ADDENDUM COUNCIL ASSESSMENT REPORT

Panel Reference	PPSSWC-148										
DA Number	4079/2017/DA-CD										
LGA	Campbelltown City Council										
Proposed Development	Concept approval of a residential development comprising 45 detached dwellings, 4 dual occupancy dwellings and 85 attached terrace dwellings in the following stages:

List all documents submitted with this report for the Panel's consideration	• Applicant's Clause 4.6 Request • Revised Conditions of Consent
Report prepared by	Grant Rokobauer – Senior Environmental Officer and Strategic Planner
Report date	2 December 2021

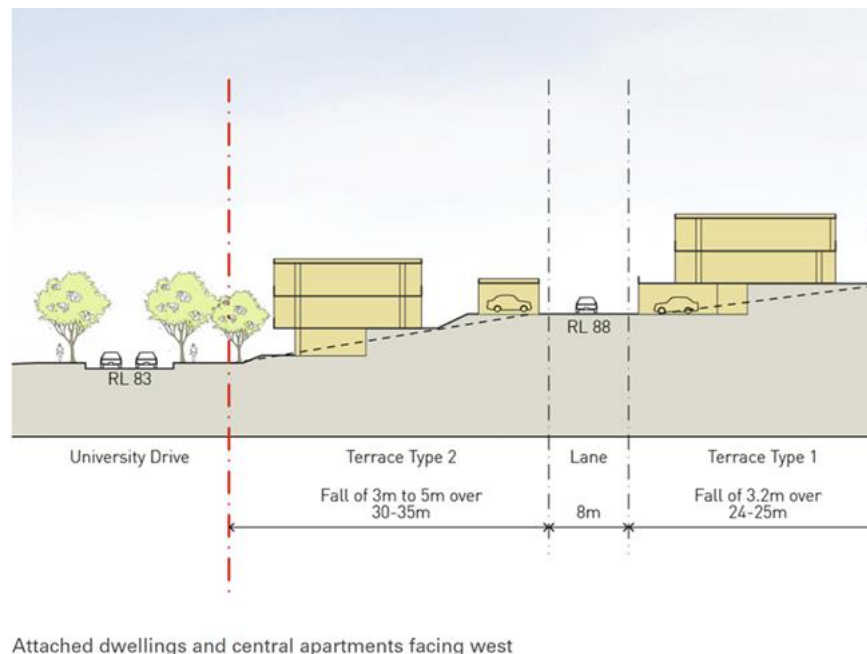
Can the Applicant be asked to clarify the proposed minimum lot width.

Second, it is uncertain what is meant by “minimum average allotment width”? If that is to be retained in the concept proposal, the Applicant should clarify how the average is to be measured (e.g. the average of lot widths within each master lot).

It may be that the planning issues address by minimum allotment width are in fact now regulated by Condition 6 which sets a maximum number of dwellings for each master lot. That seems to be the effective control.

Please clarify.

2.2 The meaning of average width

There appears to have been some confusion in relation to the use of the term ‘average lot width’. The intention of this control is to allow articulation of boundaries between lots so that wider spaces can be provided. For example, two neighbouring attached dwellings might be 8m wide for 50% of their depth and 4m wide for the remainder. This would allow each dwelling to have a wider living area in exchange for a narrower kitchen, stairwell etc. The ‘average’ is intended to refer to a weighted average of the lot across its depth.

Average lot width is calculated by dividing the area of the lot by its depth. To make this clear, Recommended Condition 2 has been amended to provide this formula.
